LHCLJ 4U0009

Installation Layouts at Point 4, 3D Integration		EHELLE SCALE 1:20	DES/DRA.	C. MAGNIER	2003-09-01
TUNNEL RB46 TOP VIEW AND SECTIONS TUNNEL RB46 VUE DE DESSUS ET COUPES			CONTROLLED	Y. MUTTONI	2007-09-04
		RELEASED	S. CHEMLI	2007-09-07	
		APPROVED	-	-	
LHCLJ_LJ_4U_3DINTP4-000_L030_L0302113PL					
REPLACE/REPLACES					
CERN	RELEASED BY	FOR	QAC	SIZE	IND.
	PROJECT ENGINEER	INFORMATION	-		
LHCLJ_4U0009				0	C

BGC_PT4 RIGHT_FPILLON

BSC_PT4 RIGHT_FPILLON

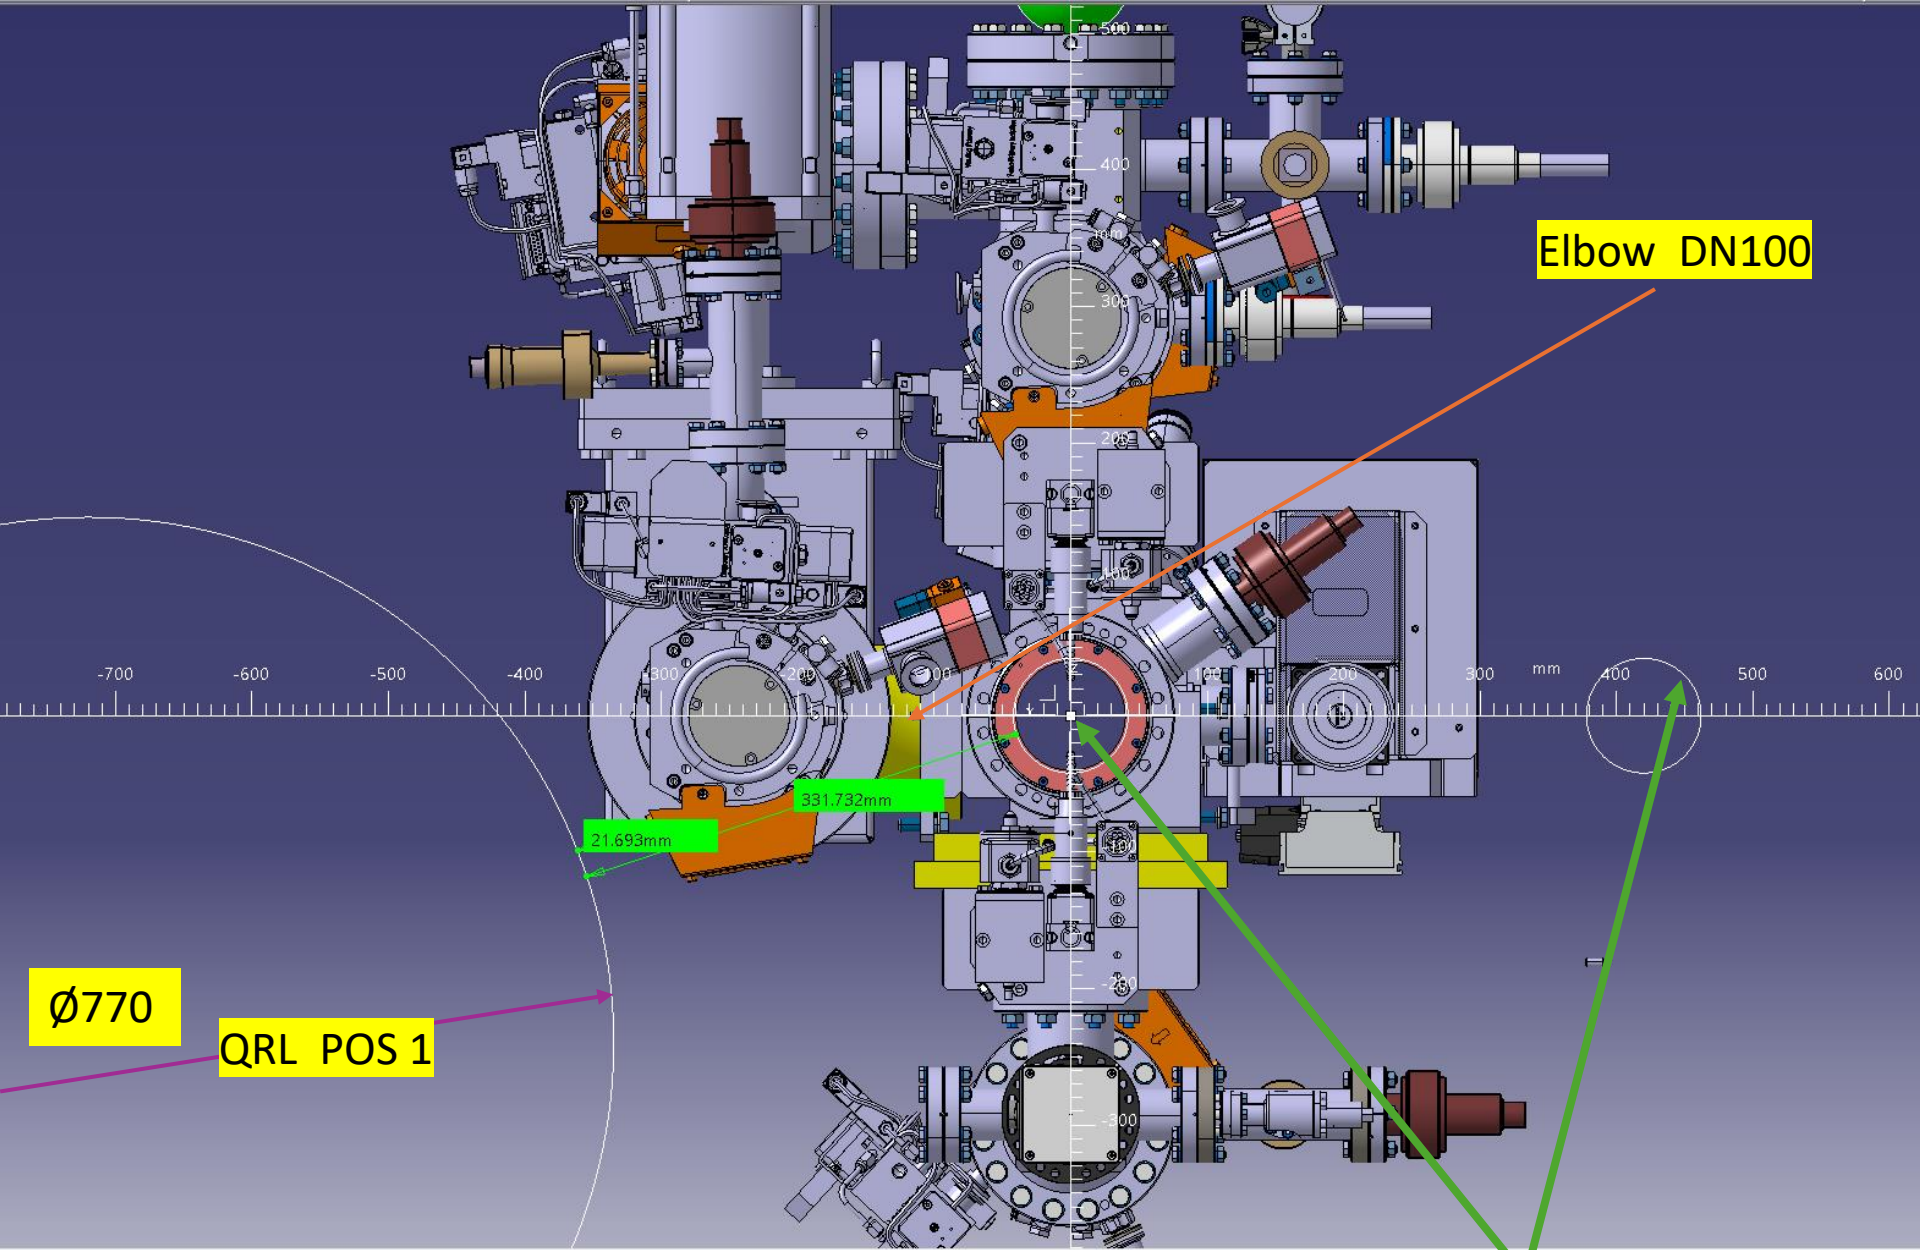
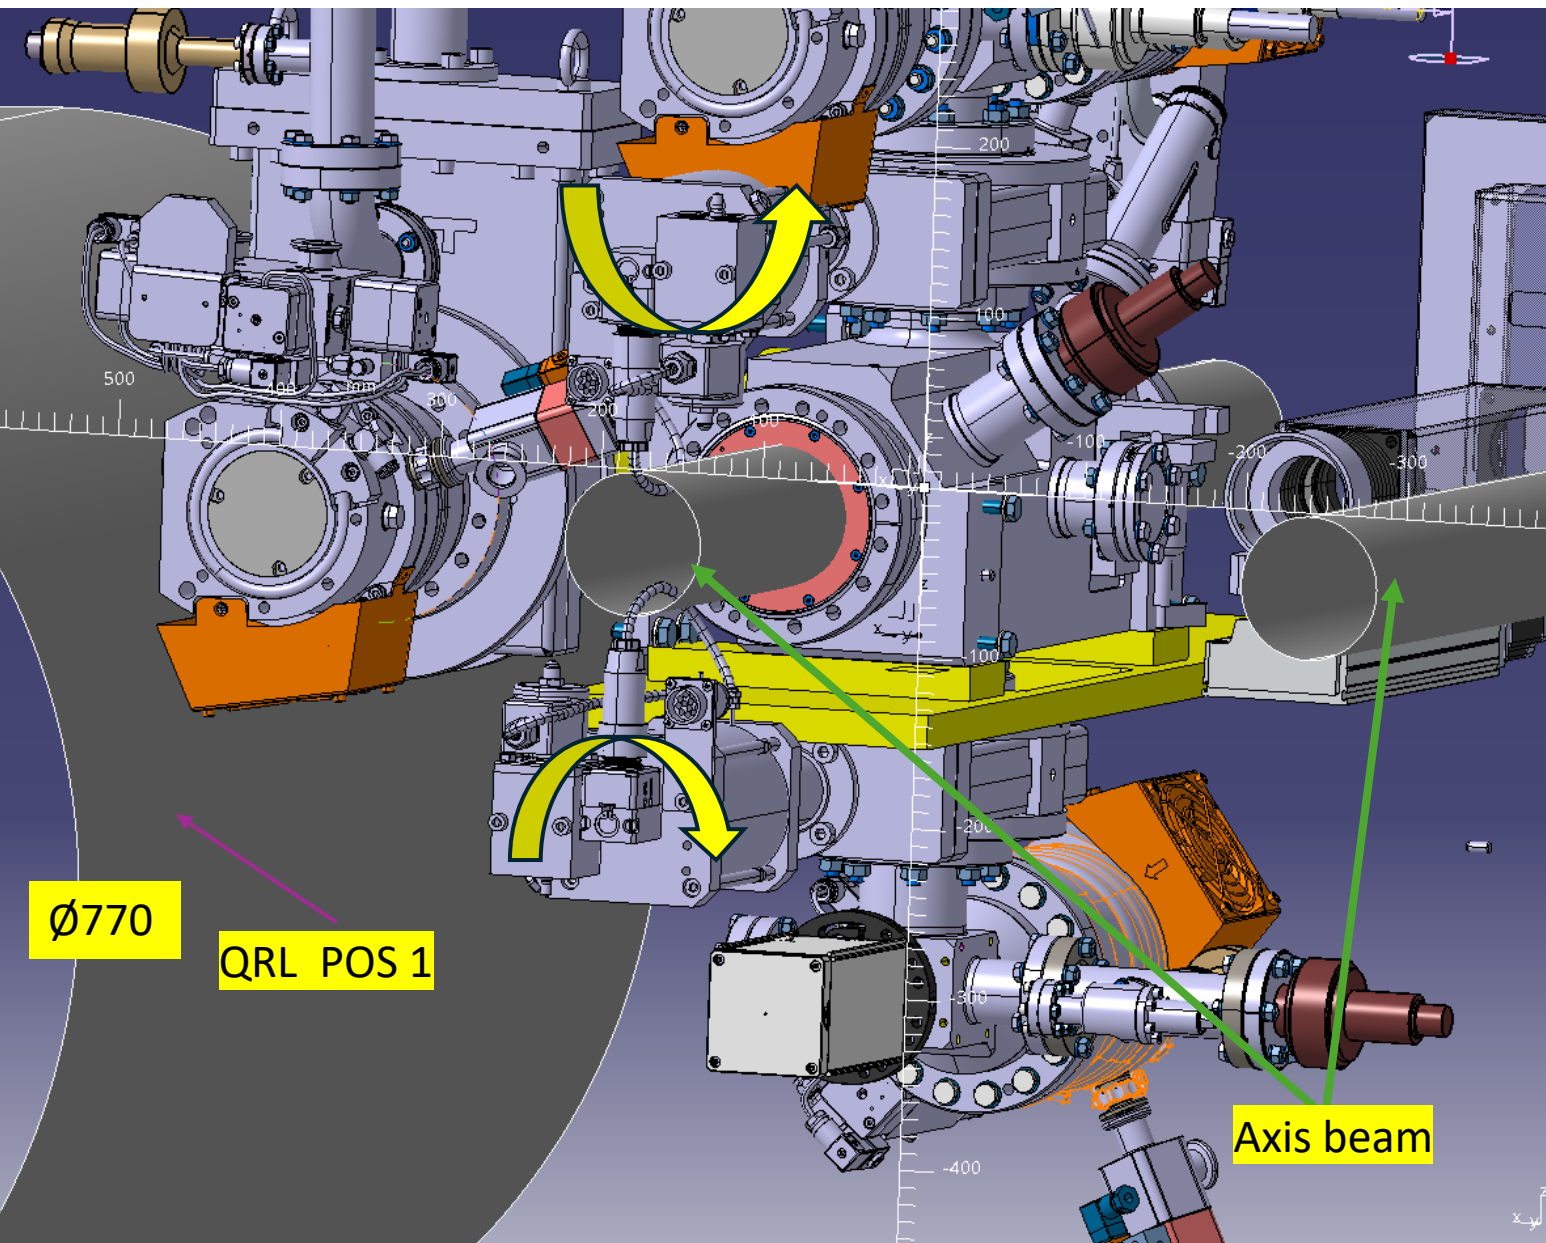
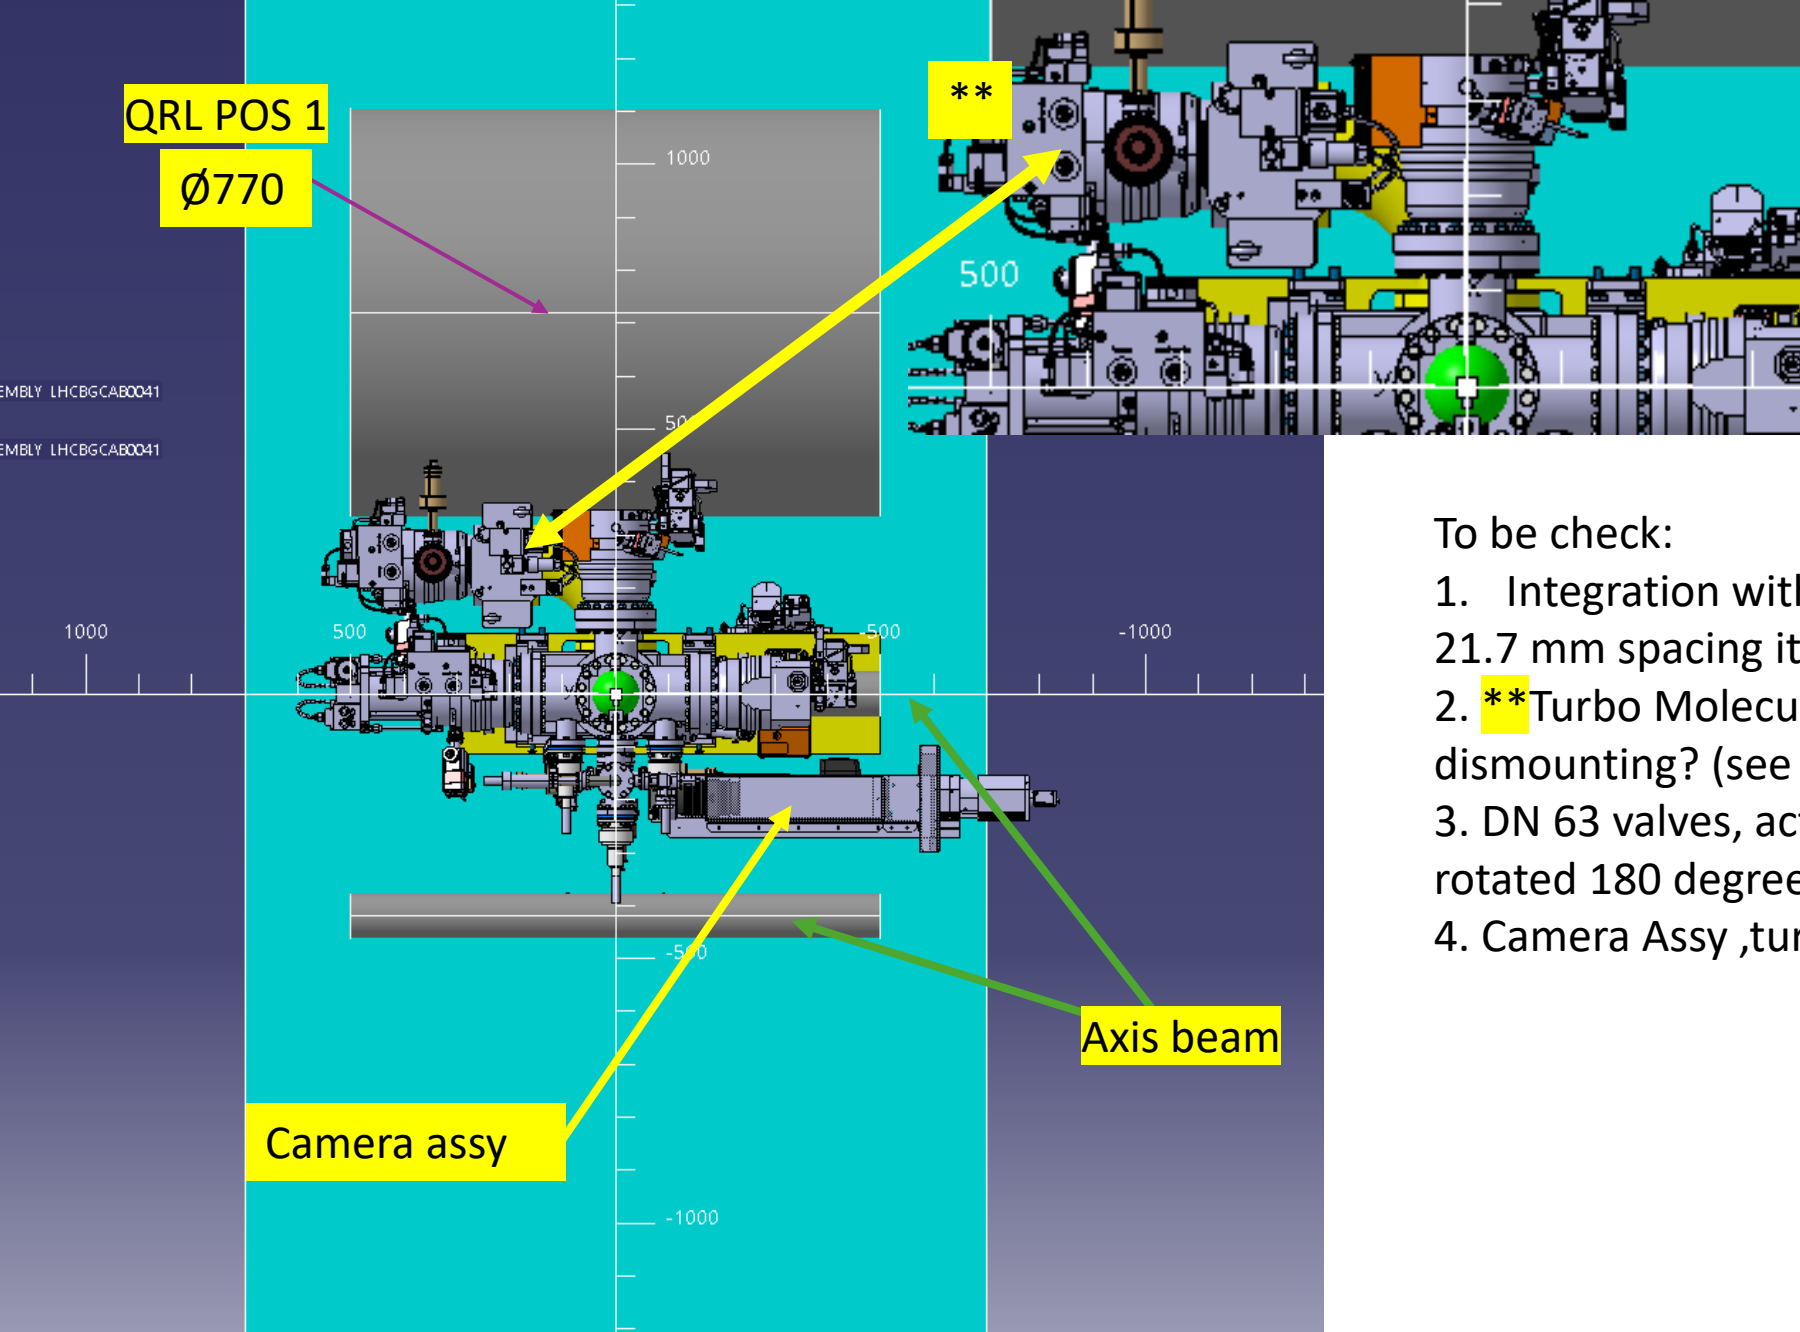
To be check:

1. Integration with Scan , Valve DN100 / QRL 21.7 mm spacing it's, ok ? (see slide 9)
2. **Turbo Molecular Pump DN100_ mounting and dismounting? (see slide 9)
3. DN 63 valves, actuator instrumentation can be rotated 180 degrees? (see slide 10)
4. Camera Assy ,turned 90 degrees possibility ?
